Process Sheet

: CU-DAR001 Dart Helicopters Services

: D3594043

: DOOR DOUBLER

D3594-043 FLOOR DOUBLER ASSEMBLY (D3594-044 OPPOSITE)

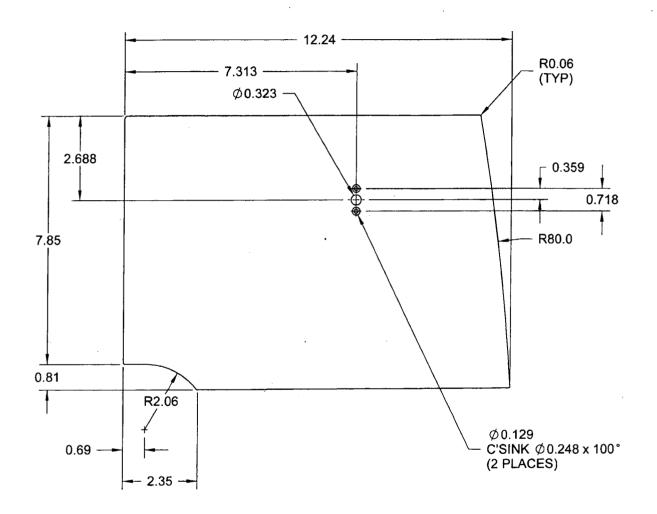
NCR:3	3527	W	ORK OR	DER NON-CONFORMANCI	E (NCR)		/	·	
DATE	CTED	Description of NC Section A Corrective Action Section B Initial Action Description Sign &				Verification	Approval	Annrous	
DATE	STEP	Section A	Initial Chief Eng	,		Section C	Approval Chief Eng	Approval QC Inspector	
07/07/13	也	holes (Allholes) are embloyedy (egg shopes)		Scrop and Destroy and Replace		80		Sn	
	20	R.C. Mixing Lbe was finished	Pasiour	CHANGED MIXING TUBE	13 0707,-13	07/07/13	Posjogy	Aspis	
Muzib	5-0	I pant the hole is two deep on the c'sink! LC: Human error	/ .	1 10 5 10	mF-7-07-11	07/07/06	dasion	Poror	
		Q:>1042			, w		NOX 042

Good afternoon. I had 4x D3594-043 doublers B33523, and 4x D3594-044 doublers B33524, that needed to be re-worked. For the -044, 2 parts were incorrectly counter sunk, resulting in the hole being slightly over sized. For the -043, 1 part was counter sunk too deep, which would have resulted in a bad assembly, meaning in correct riveting (a tiny gap between the material, and the rivet head). I had the parts re-worked by filling the holes necessary with weld, seeing as how the material was 6061-T6, and ground flush to the surface, then transfer drilled too the drawing. The hole sizes were only 0.129". Is this acceptable to you?

As these parts are for the D412-698-023 Door Opener Kit and the rivet holes are used to install a nutplate, the rework you have outlined below is acceptable to me.
